Response to Submissions No.2

Ivanhoe Estate
Concept Masterplan SSD17_8707

Submitted to Department of Planning and
Environment
On behalf of Aspire Consortium

11 October 2019 | 17156

Table 4 Epping Road Building Envelope Setbacks

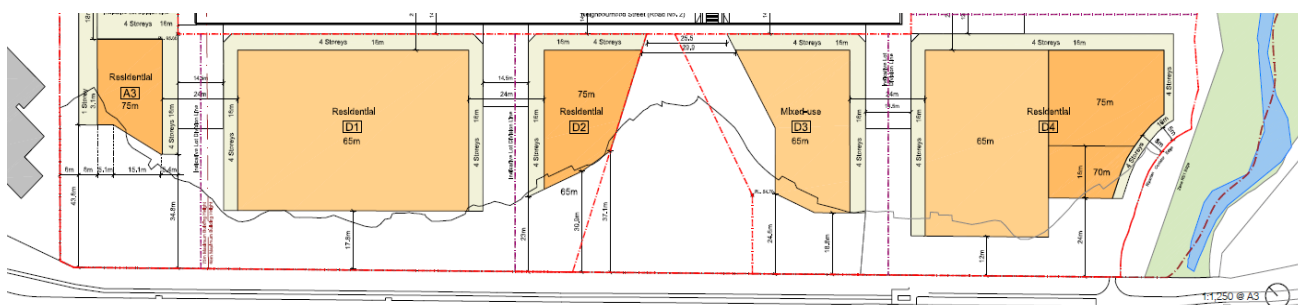
The building envelopes of A3, D1, D2, D3 and D4 have been significantly amended to increase the building and basement setback to Epping Road. Accordingly, the setback to Epping Road will range between 17.8m to 43.6m for building envelopes adjacent to the Sydney Turpentine Ironbark Forest and 12m to 24m to Block D4. The table below depicts the changes in setbacks to Epping Road and **Figure 3** and **Figure 4** illustrate the setback changes.

Development Block	Epping Road Setback as originally exhibited	Epping Road Setback as amended (RTS 1)	Epping Road Setback as proposed to be amended (RTS 2)
A3	10 metres	18 metres	34.8 – 43.6 metres
D1	10 metres	12 metres	17.8 metres
D2	10 metres	12 metres	23 – 37.1 metres
D3	10 metres	18 metres	18.8 – 24.6 metres
D4	10 metres	12 – 24 metres	12 – 24 metres

Figure 10 Refined indicative basement design

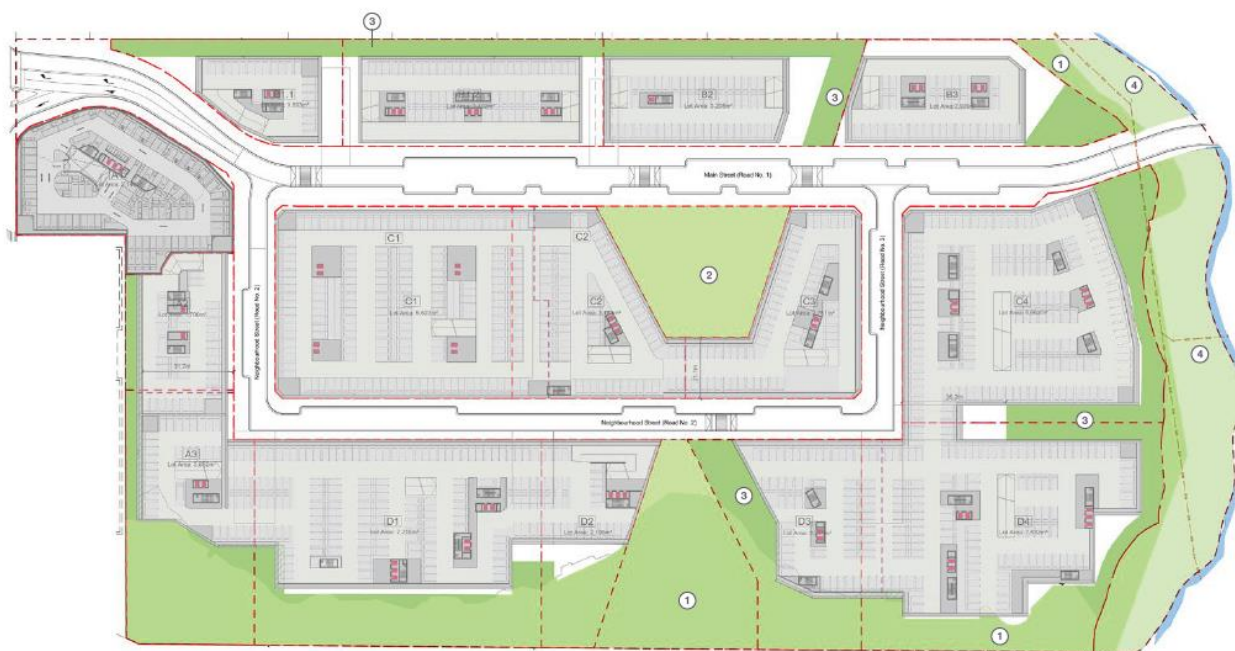
The Indicative Design Scheme at **Appendix E** illustrates that the basement design has been refined to provide increased setbacks along Epping Road and the Shrimptons Creek riparian corridor. Importantly, the basement has been refined to ensure that the basement does not encroach beyond the building footprint to the setback areas of

Epping Road and Shrimptons Creek. These increased setbacks allow for additional potential deep soil planting areas and the preservation of biodiversity. Accordingly, the deep soil area of the site as a percentage has been increased from 17.6% to 22.2%. An illustration of the refinement of the basement and the ability for vegetation to be retained and future deep soil planting to be provided is provided at **Figure 10**.

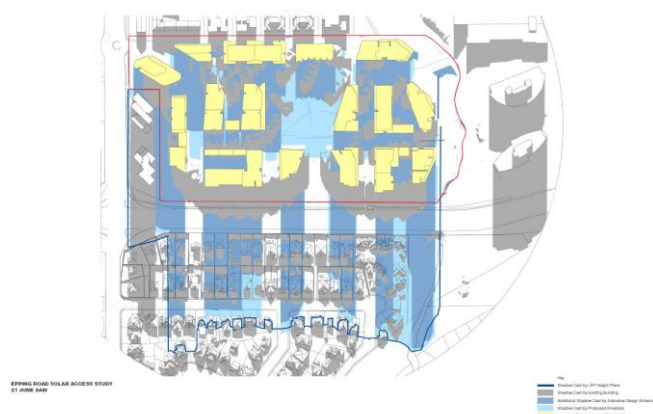
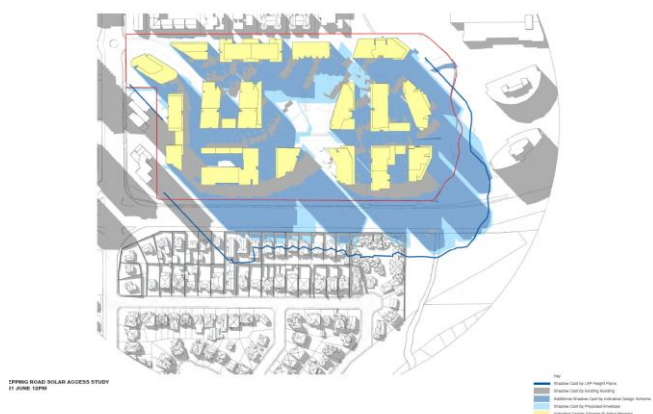
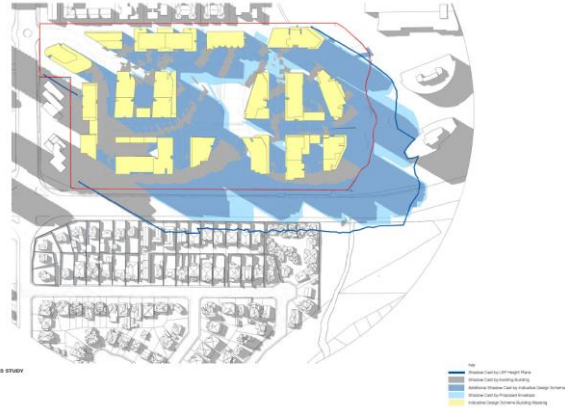
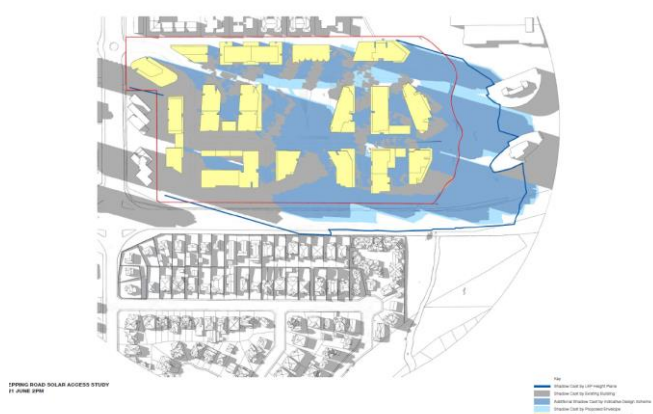
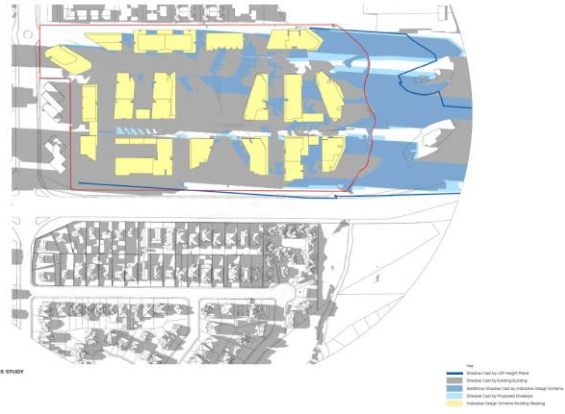
With respect to the additional height variations in the RTS 2 scheme, the location of these buildings within the centre of the site means that the additional shadows created by these buildings largely fall on or within shadows cast by the other buildings in the Ivanhoe Estate, and therefore do not generate additional shadows that impact on adjoining residential properties.

In light of the above, the overshadowing impacts created by the proposal, in particular the RTS 2 scheme, are considered to be minor and acceptable, are not significantly accentuated by the proposed height variations and are an improvement on the impacts previously exhibited.
